Information Only Service Note

N5183B X-Series MXG μ Wave Signal Generator

The Problem – Recommending using Refurbishment Part Number for Self Test 1105 and 1304 failures due to excessive reverse power by user.

Figure 1 - A3 RF Output Switch - U13

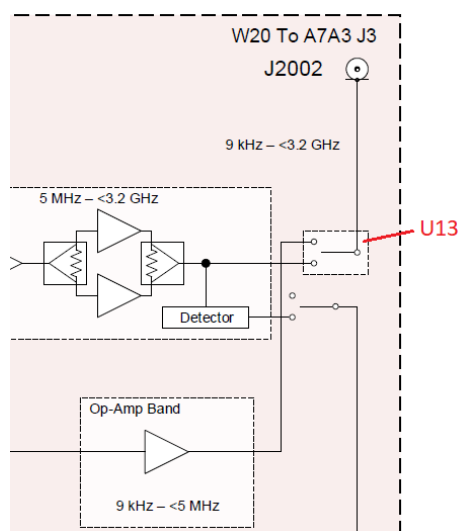
The component level part on the A3 RF assembly that typically gets damaged under these conditions is the RF output solid state switch (U13) as shown in Figure 1, which is taken from a block diagram in the instrument service guide.

When U13 is damaged in this way it may either be stuck in one position or the other, or it may not pass any signals at all.

- a) Replacement part for repair – to use refurbishment part number because the damage is most likely caused by excessive reverse power being applied to the RF output by the user.
